Chapter 5
Items 5-1-12 through 5-24-12
August 21, 2014.

This is one of eight documents containing the preliminary actions of the A117.1 Committee regarding public comments received on the First Public Review Draft (October 2013) of proposed changes to the A117.1 Standard, 2009 edition. Each item was discussed at the meeting of Committee during the weeks of January 21st and July 14th of 2014, in Washington D.C. The Committee took action on each public comment and such action is specified herein. The actions listed here are subject reconfirmation by the Committee via the Committee's ballot process.

Chapter 5

FIGURE 504.1

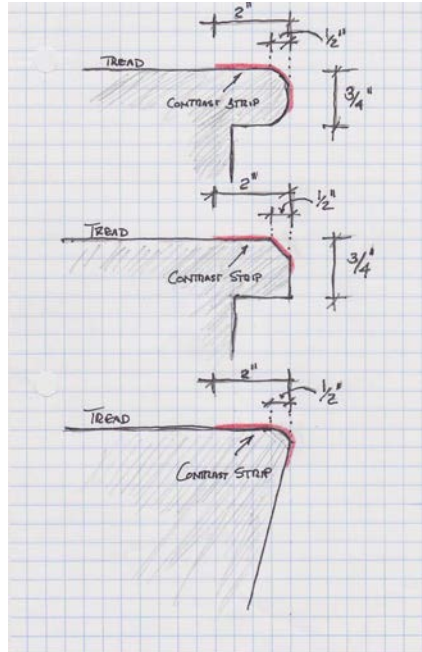
504.5.1 Visual contrast.

505.5.1.1 Every tread and landing shall have two surface colors for visual contrast, dark on-light or light-on dark.

505.5.1.2 The contrasting color of the leading edge of the tread or landing shall:

- a. Extend the full width of the tread or landing.
- b. Start at a line 2 inches (51 mm) back from the furthest point of the nosing and,
- c. Extend on the tread or landing toward the nosing, perpendicular to the path of travel, continuing to cover the profile of the nosing and down the riser until the color has extended 3 inches (75 mm) from the start line.

Reason: The concept in Proposal 5-13-13 has great merit, but the committee was unable to agree on adequate language to describe the contrasting edge stripe so that it is clear as to what is required. The proposed language and figure do that.

Approve with modifications – 5-13-12 PC1

504.5.6 Visual contrast. Visual contrast shall comply with either Sections 504.5.6.1 and 504.5.6.2, or Section 504.5.6.3

504.5.6.1 The leading 1 to 2 inches (51 mm) of every tread and landing, measured horizontally from the leading edge of the nosing, shall consist of a solid color having visual contrast of dark-on-light or light-on-dark from the remainder of the tread.

504.5.6.2 The contrasting marking shall be durable, and shall extend from one side of each tread to the other side of each tread.

504.5.6.3 Durable distinctive warning markings required by the adopted building code or ANSI safety standard.

Reason: As with nosings, applying the visual contrast concept to the stairways had resulting in considerable discussion. The committee, upon reconsideration, approved 5-13-12 based on a modification of PC1. It is a companion piece to the modification approved under 5-11-12. Both provide
